Your ref
Y/42/20/PL

Our ref
PLAN-032971

Proposal: Extension & alterations to main dwelling & conversion & extension of existing annexe to 2 No. holiday letting units (resubmission following Y/117/19/PL).

Site: Y/42/20/PL: - The Crickets, Hoe Lane, Flansham, Yapton, PO22 8NT.

Southern Water MapGuide Browser

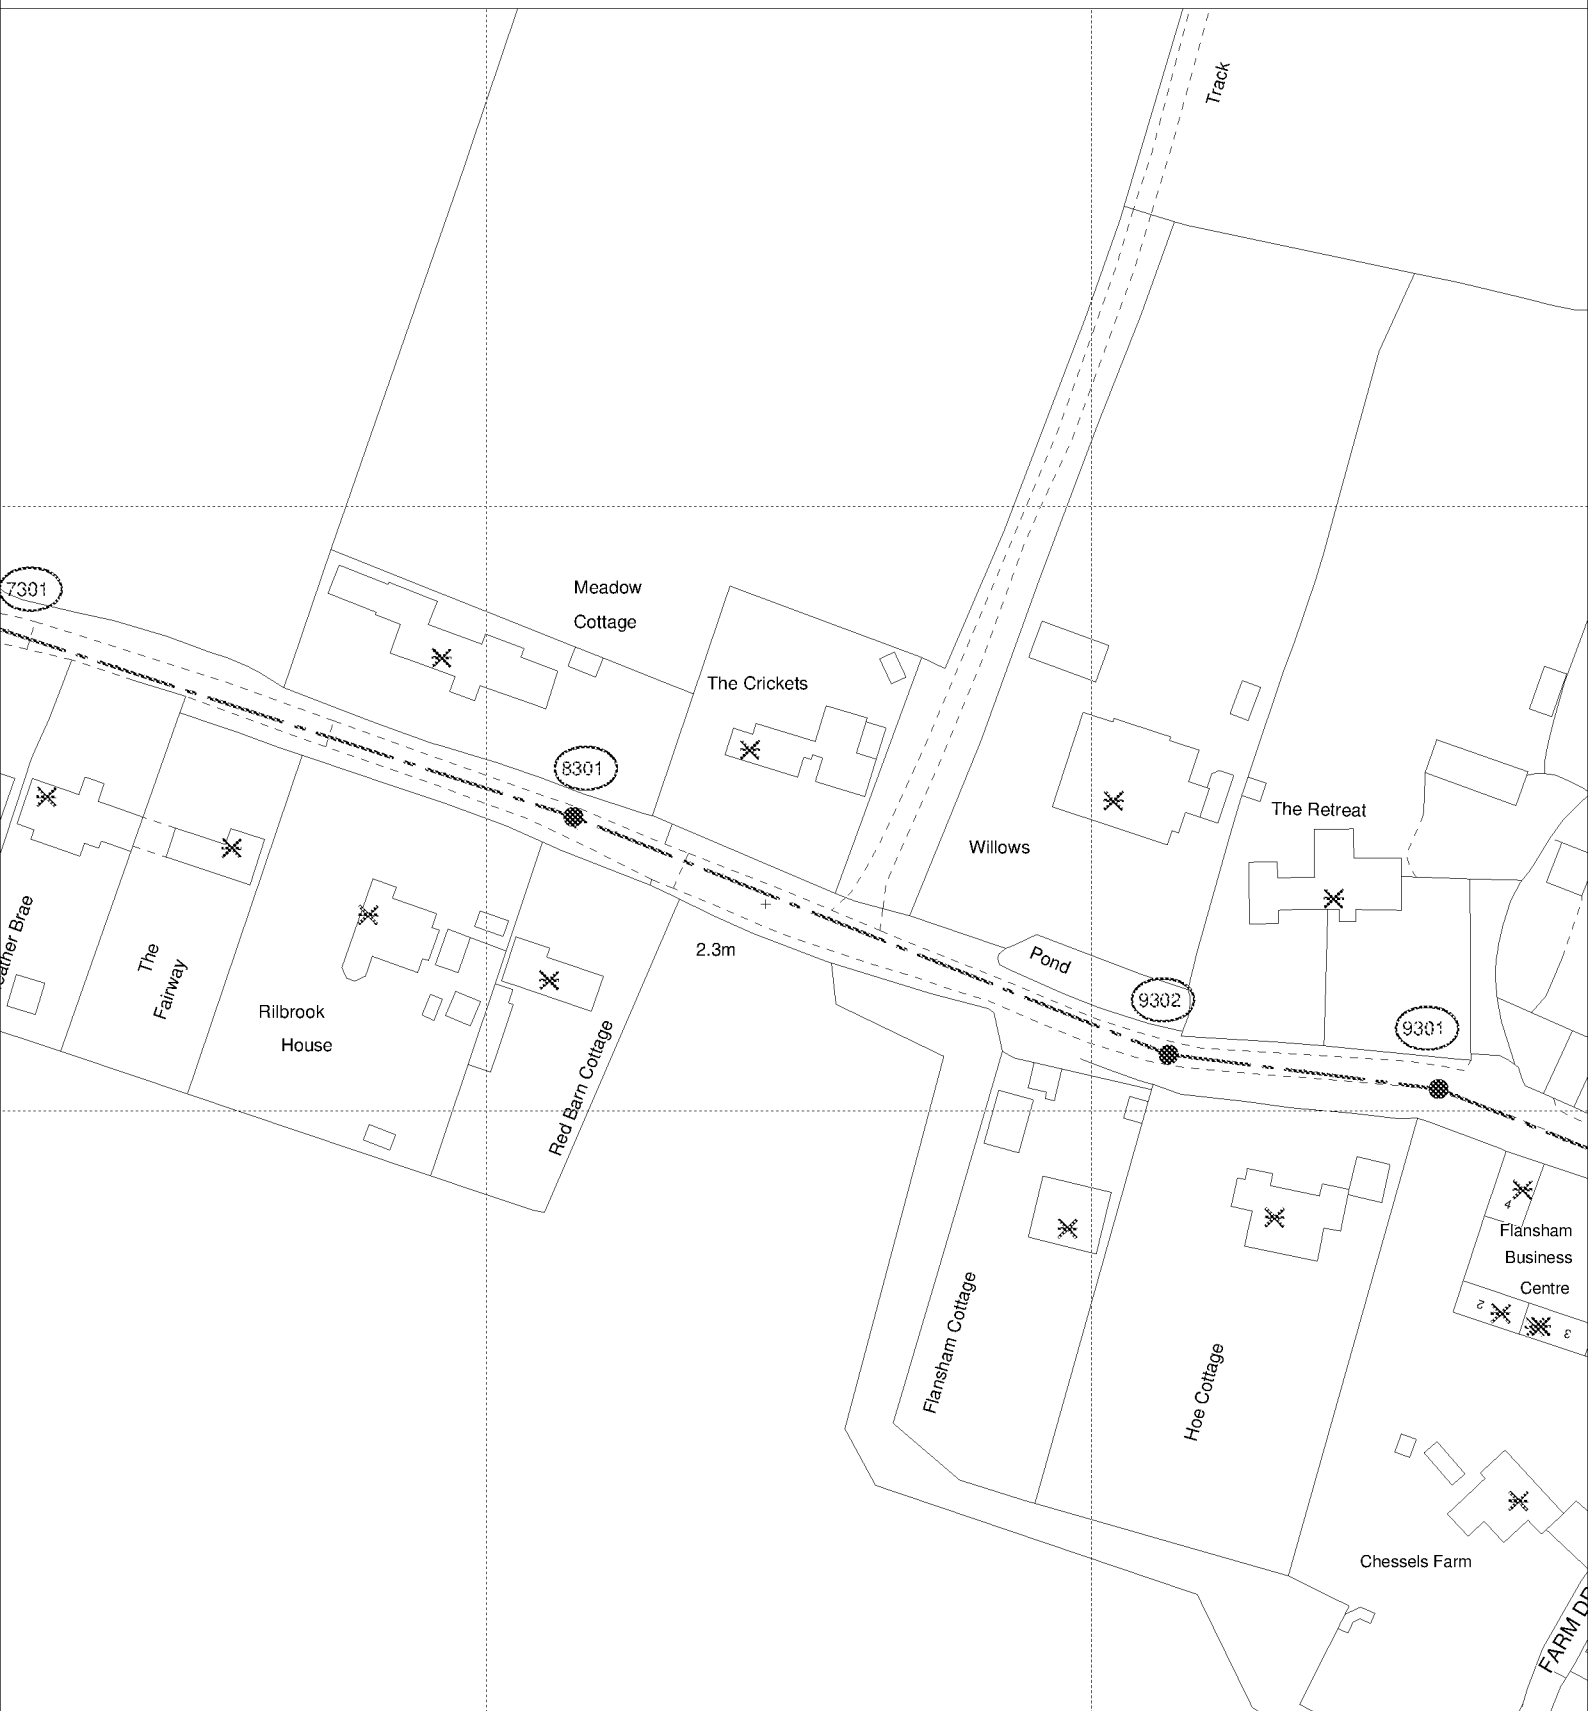
It is possible that a sewer now deemed to be public could be crossing the development site. Therefore, should any sewer be found during construction works, an investigation of the sewer will be required to ascertain its ownership before any further works commence on site.
